Technical Bulletin

FAI Cylinder Heads

Affected part numbers: BCH029, BCH030, BCH032 & BCH104

TB0061

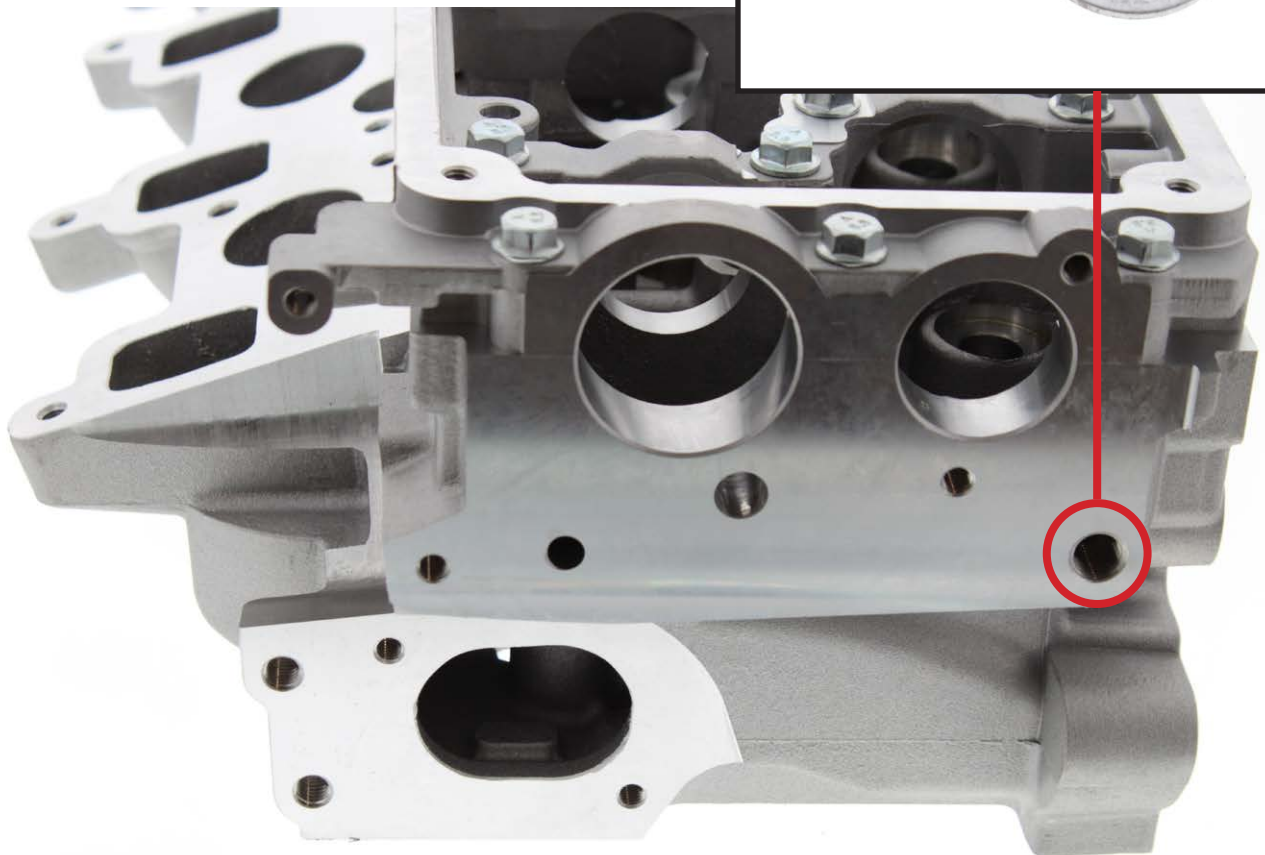
Some applications have auxiliary components that use the oil feed hole as shown below. If the application you're working on doesn't require this function, the hole must be plugged with the screw and washer provided.

Failure to do so will result in a loss of oil & oil pressure and any damage, as a result, will void the FAI warranty.
